COA # 2010-COA-033 (RP)	INDIANAPOLIS HISTORIC PRESERVATION COMMISSION STAFF REPORT	Hearing Date APRIL 7, 2010
916 N California RANSOM PLACE		New Case
Applicant ROBIN ALTMAYER mailing address: 916 N California St Indianapolis, IN 46202		Center Township Council District:15 Andre Carson
Owner: same		
CASE		
IHPC COA:	2010-COA-033 (RP)	<ul style="list-style-type: none"> • Demolish rear additions • construct new rear addition • replace siding with fiber-cement siding • replace windows with vinyl • replace inappropriate front door with new door
STAFF RECOMMENDATION: Approval of a Certificate of Appropriateness

STAFF COMMENTS

Site Plan (Above)
Roof Plan (Below)

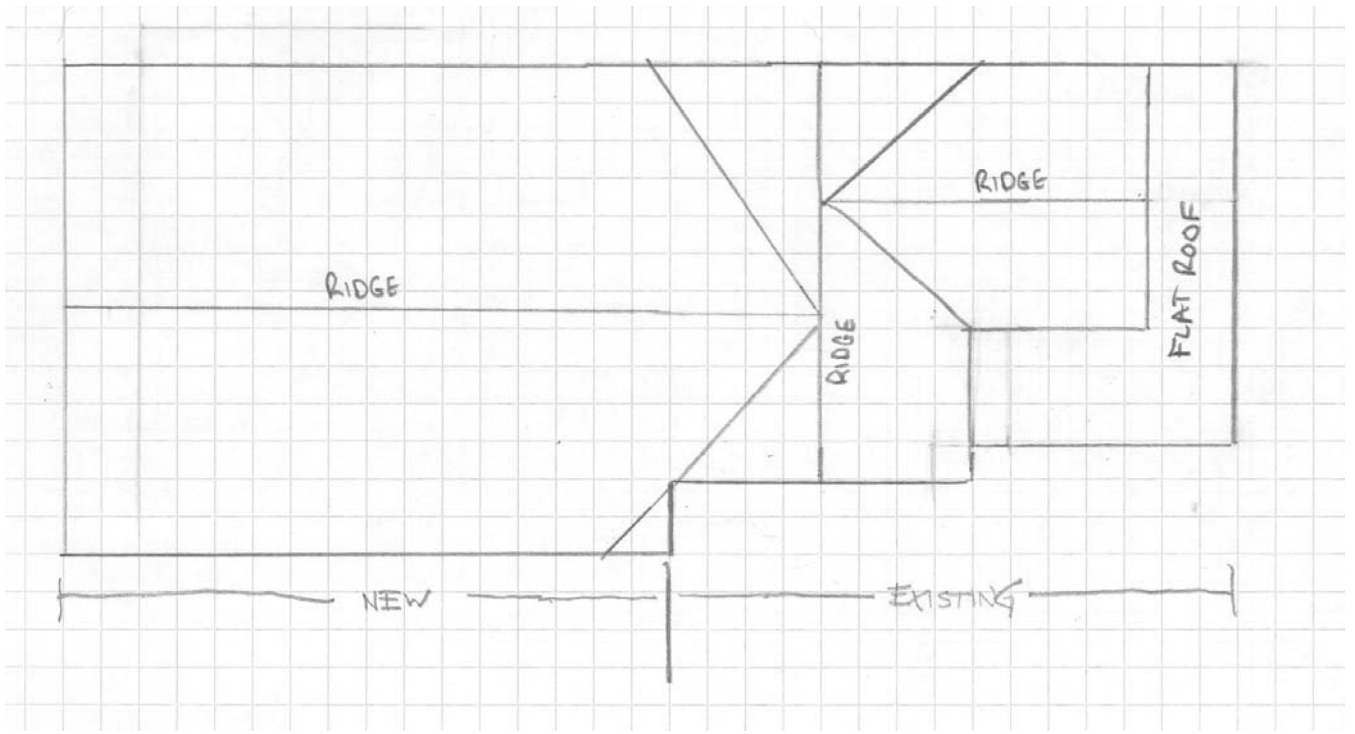
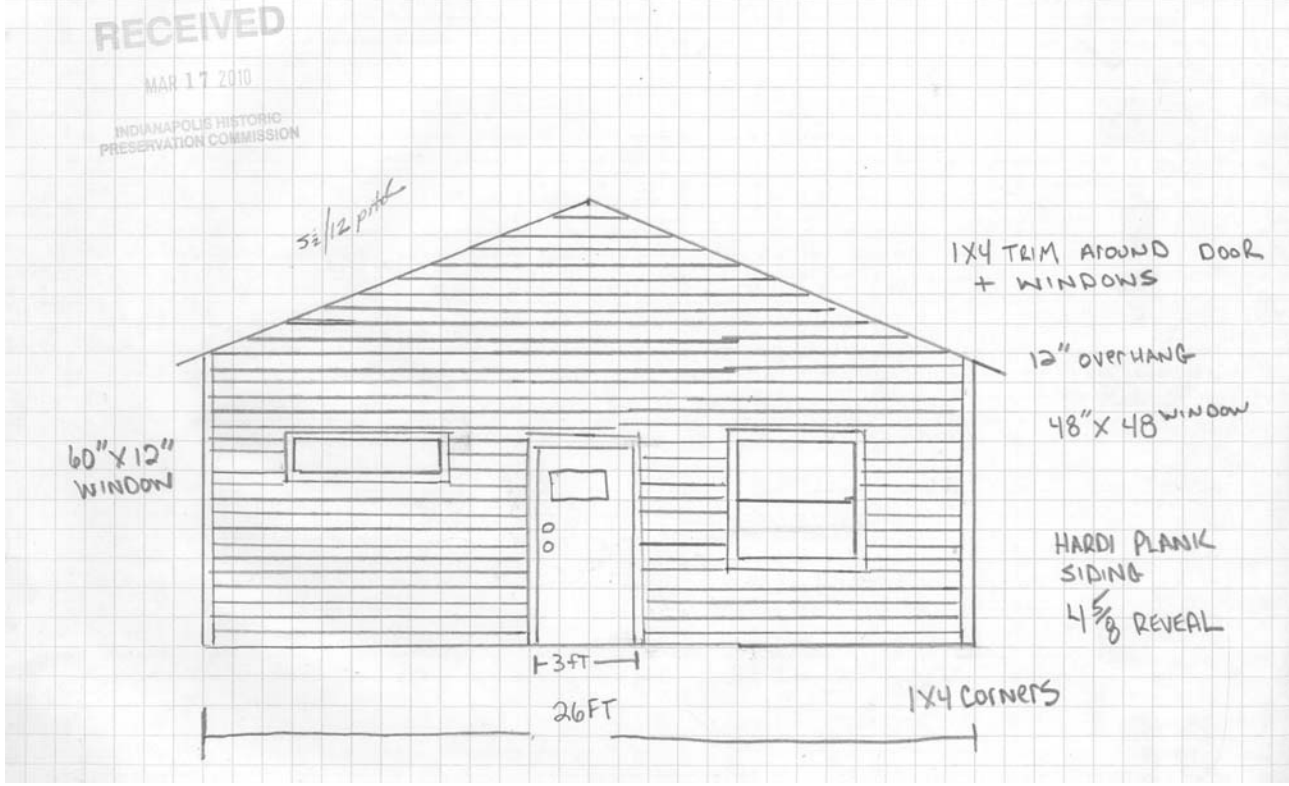
The new addition will be approximately 16 inches wider than the existing addition and therefore project beyond the south side of the house. The new addition is 12 feet longer than the present addition. The side projection is needed avoid the need to completely excavate the existing foundation.

At this point, the plans are inadequate, but given the simple nature of this addition, we believe we can work with the owner to get final plans with adequate detail.

- It is consistent with the following guideline in the Ransom Place Conservation Plan: *“Additions to historic buildings should not obscure or overpower the basic form and style of the building as perceived from the street.”*
- Although there will be a 16 inch projection on the south side, that detail will not overpower or obscure the main body of the structure.

To approve a Certificate of Appropriateness to demolish the rear additions, build a new rear addition, replace windows, replace front door and install fiber-cement board siding on all four elevations per submitted documentation and subject to the following stipulations:

- 1) Construction must not commence prior to approval by IHPC staff of final construction drawings. *Approved: _____ Date: _____*
- 2) A pre-construction meeting between IHPC staff, the designer, the owner, and the contractor/construction manager must be held prior to commencement of construction. *Approved: _____ Date: _____*

Above: Rear Elevation (Proposed)
Below: North Elevation (South Elevation will be mirrored)

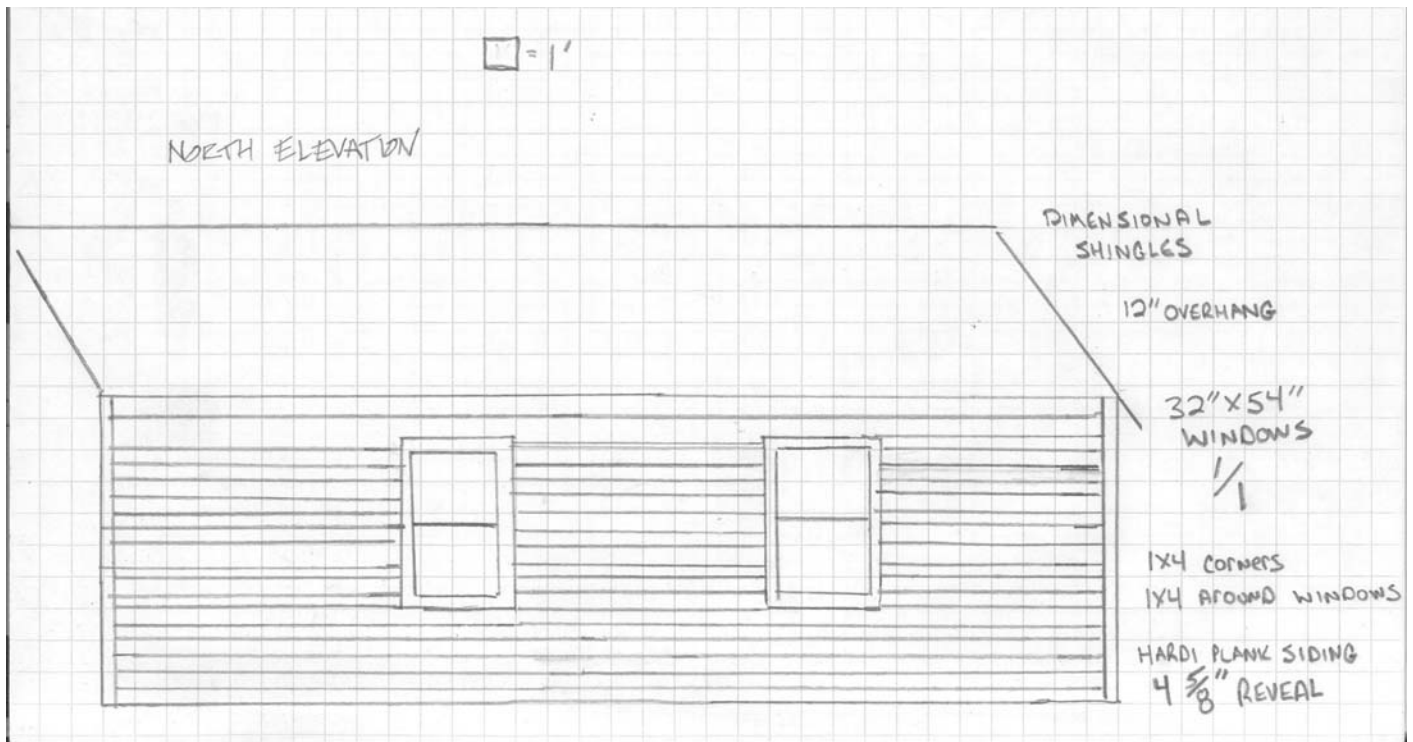
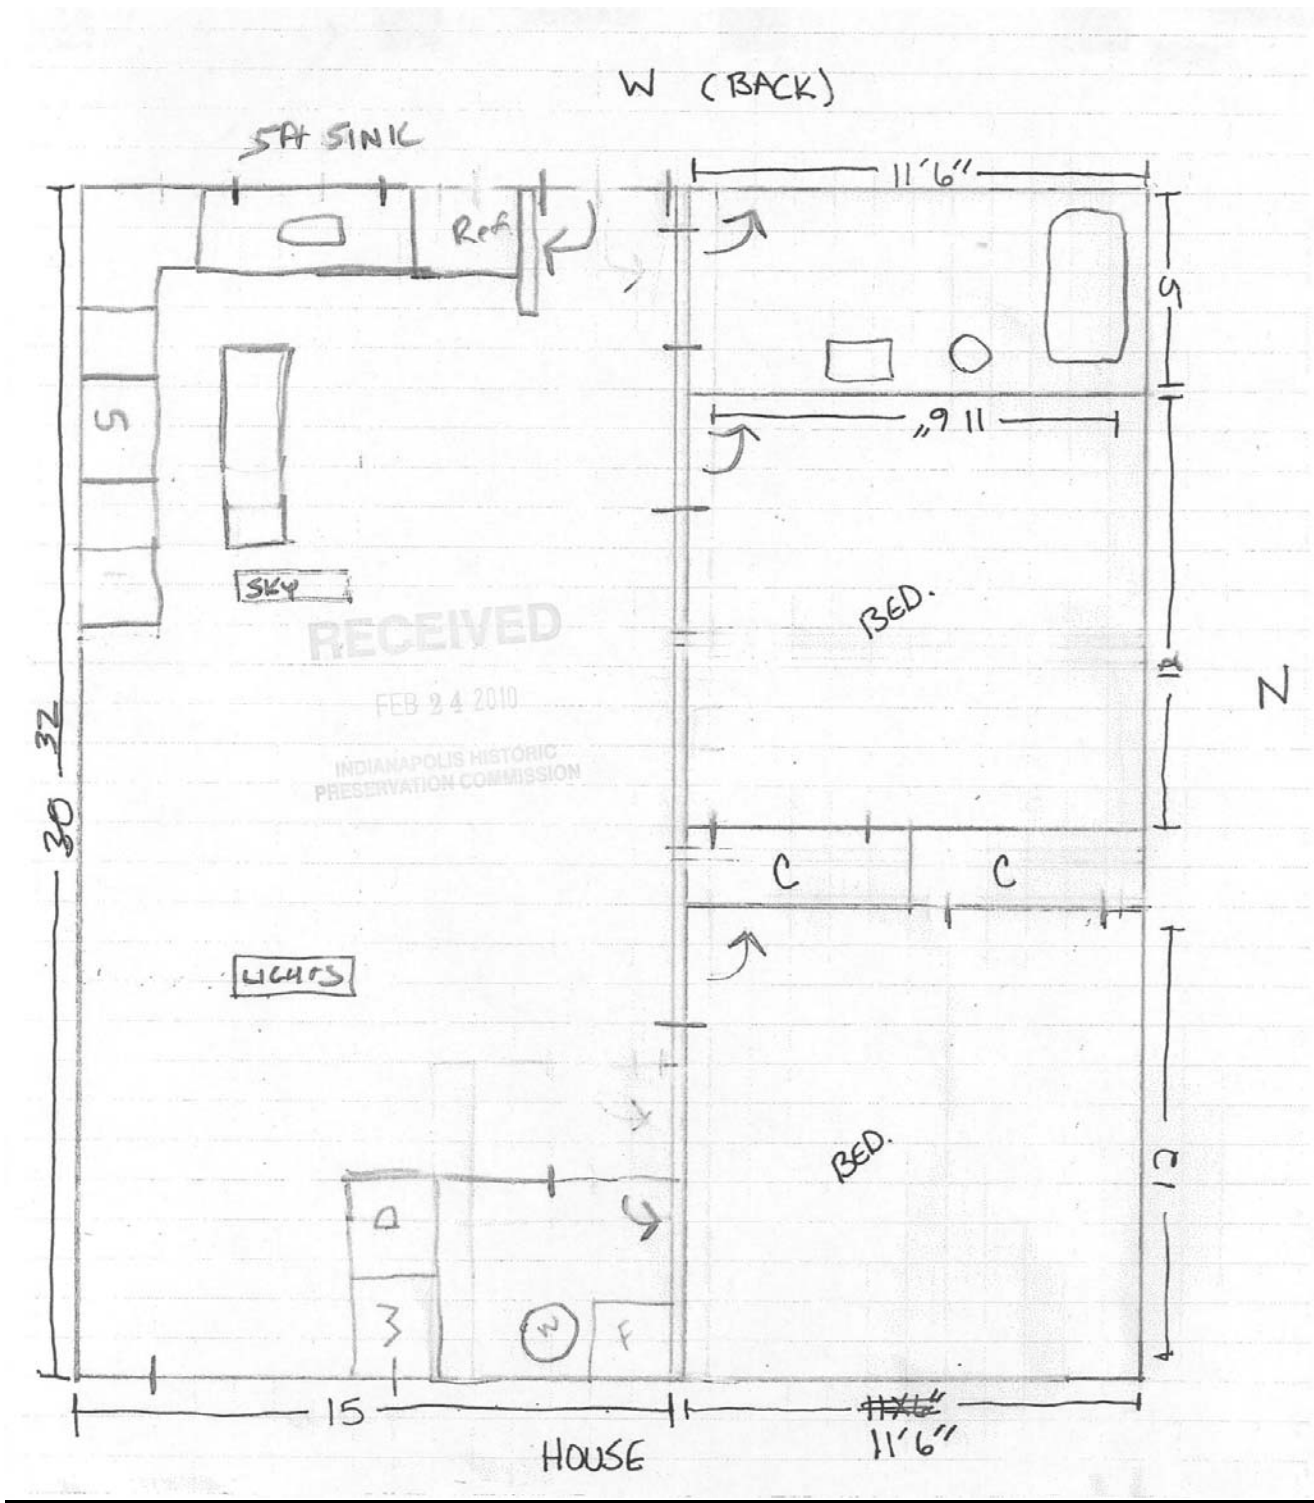
- The design of the addition is not inappropriate for the structure. It is a one-story addition just like the house and will have the same siding and windows as proposed for the rest of the house.
